HISTORIC DISTRICT COMMISSION NOTICE OF DENIAL

Application Number: HDC2025-00154

HISTORIC DISTRICT COMMISSION ADDITIONAL INFORMATION REQUEST

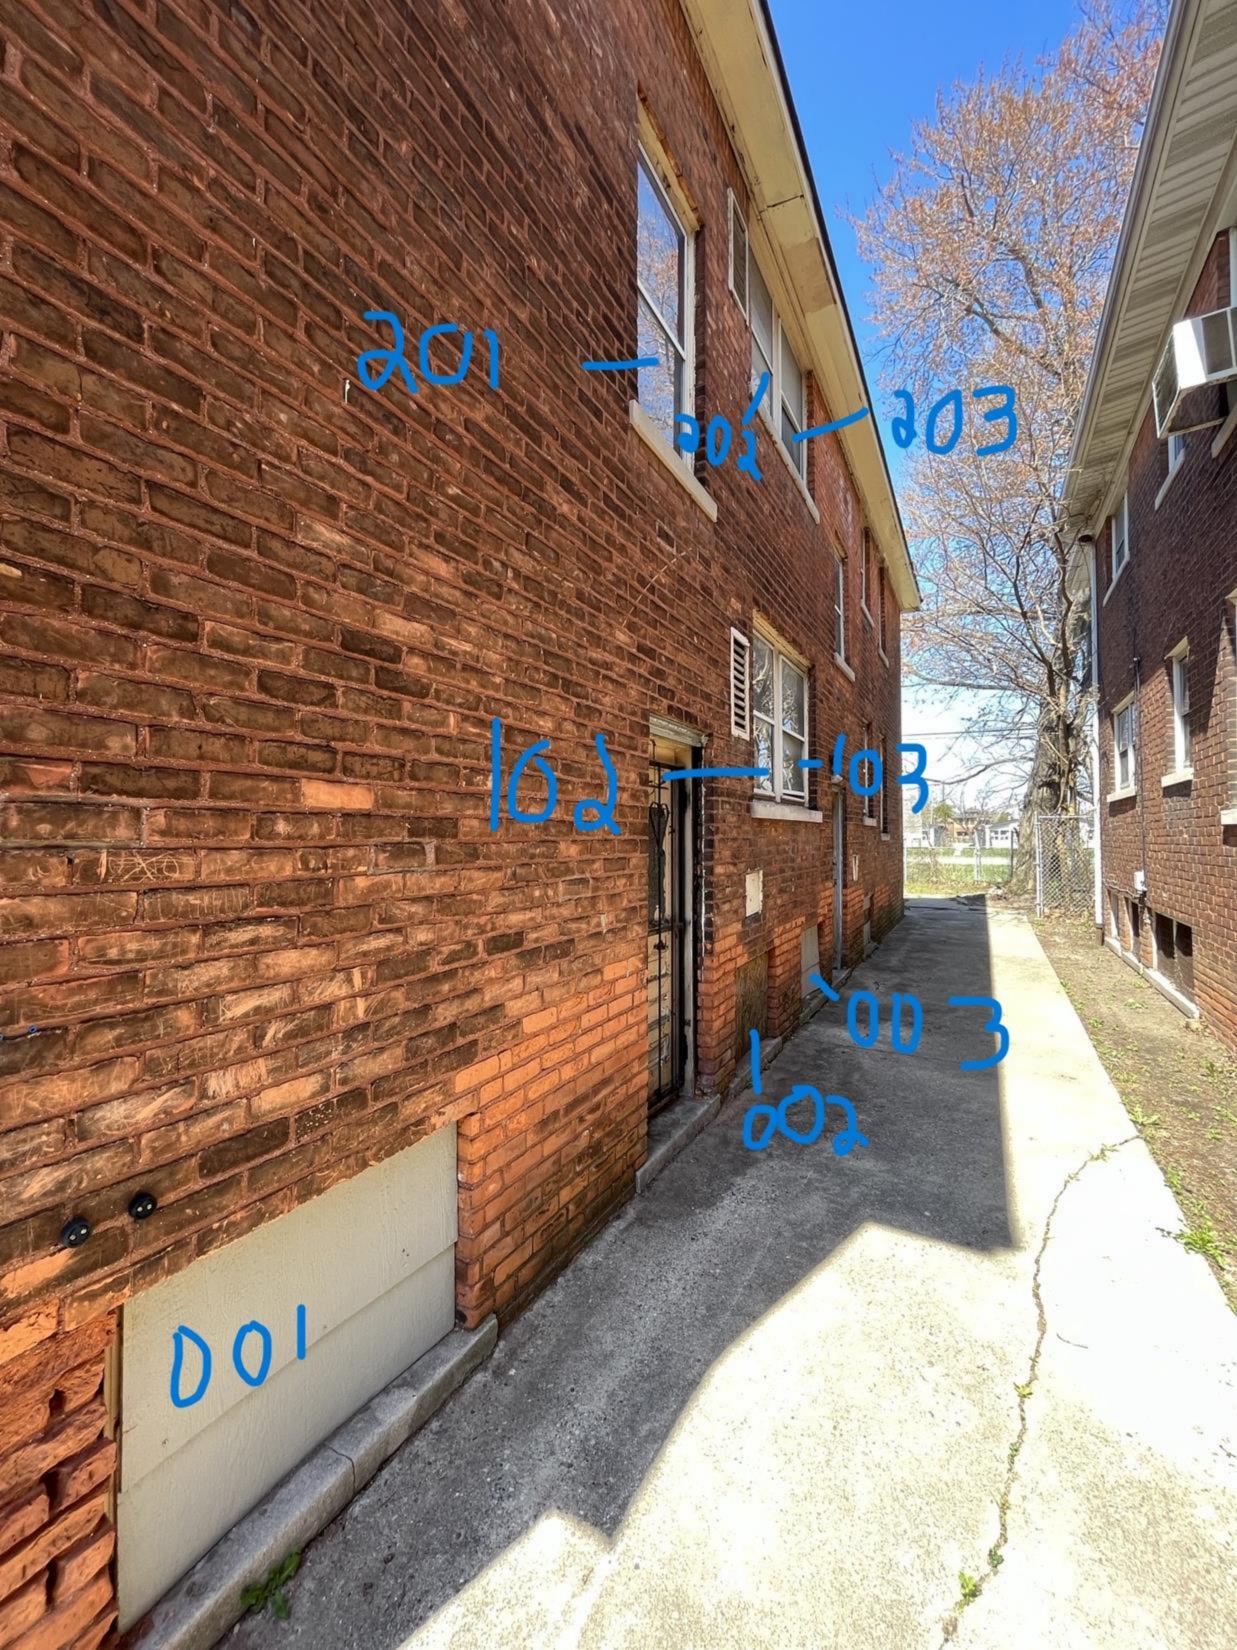
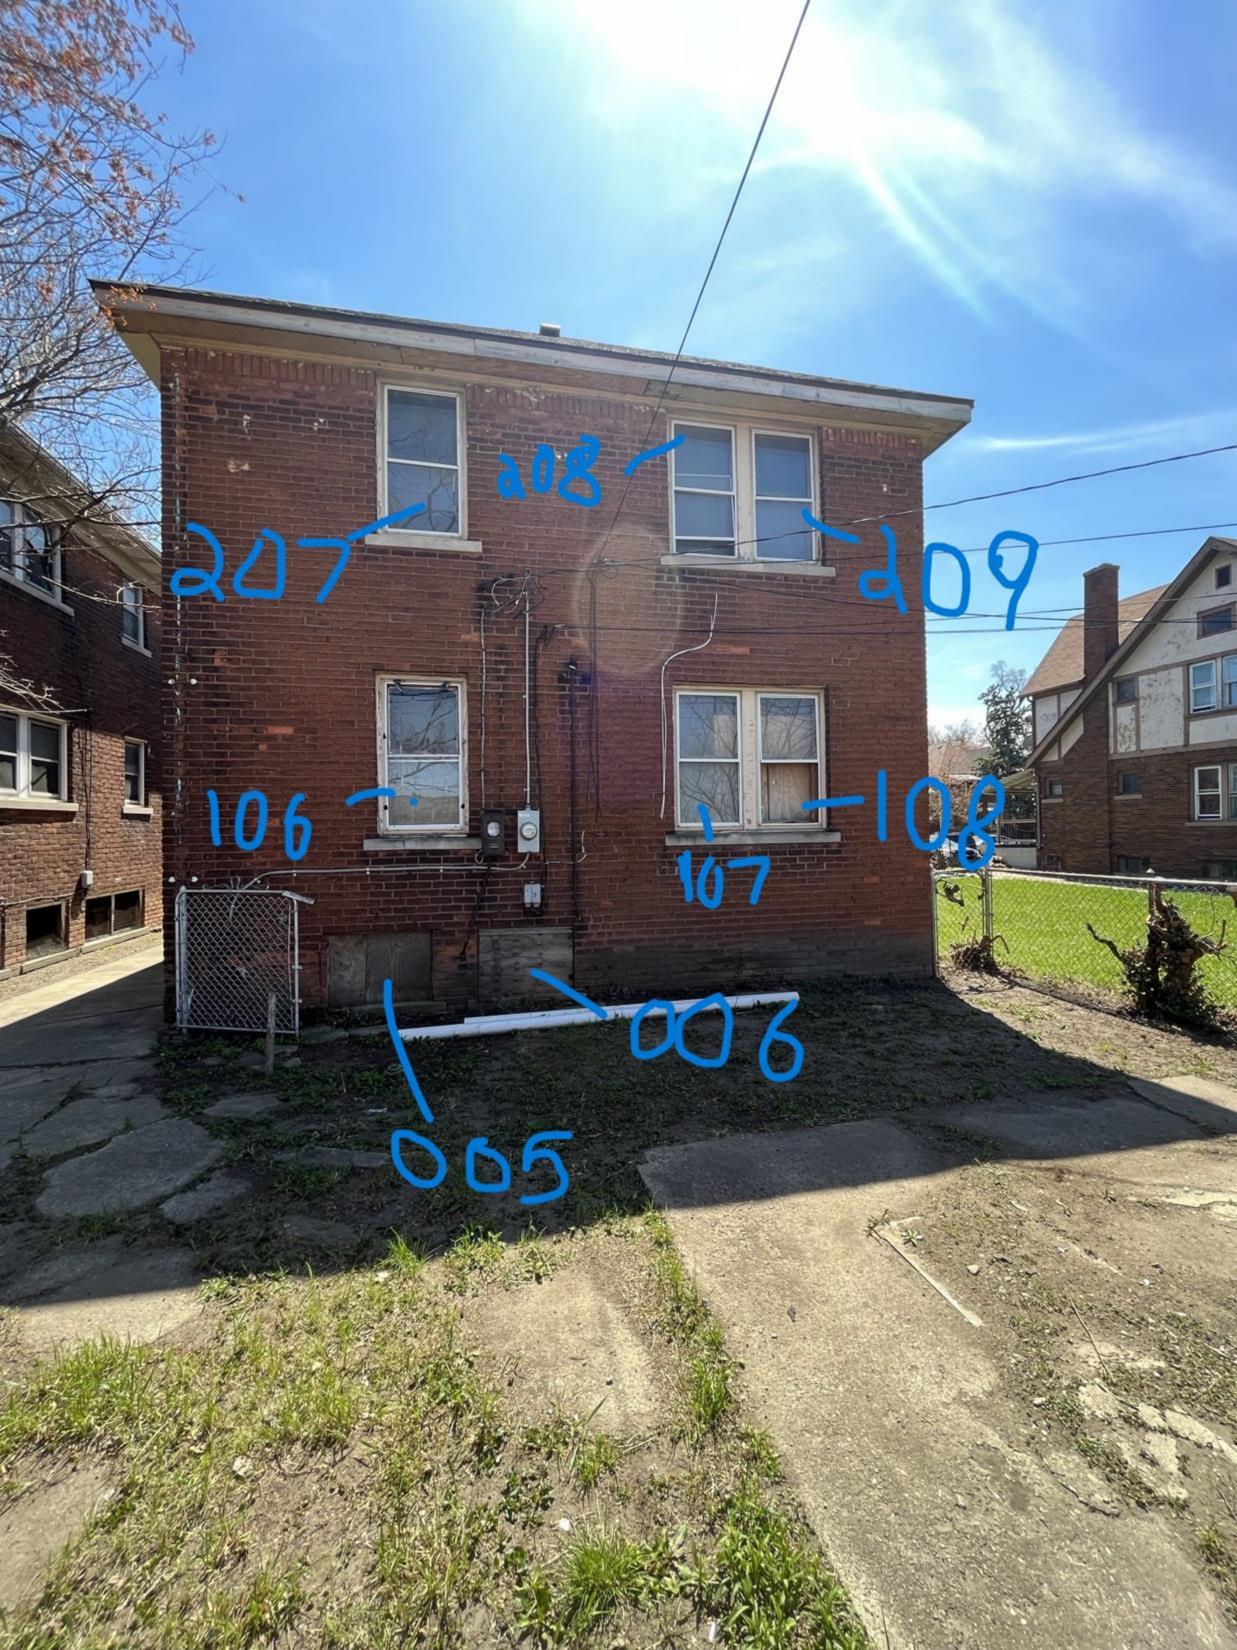
• Window schedule, which describes the existing windows in material and operation & shows the proposed new windows, their material, operation, dimensions, and color

• Photos of the exterior elevations of the house with labels that show which windows on the window schedule are being placed where

The windows are labelled on each elevation, the east elevation had to be done in parts due to space constraints. Windows will be a light beige exterior, aluminum clad.

The labels correspond to the "locations" on each line of the window schedule
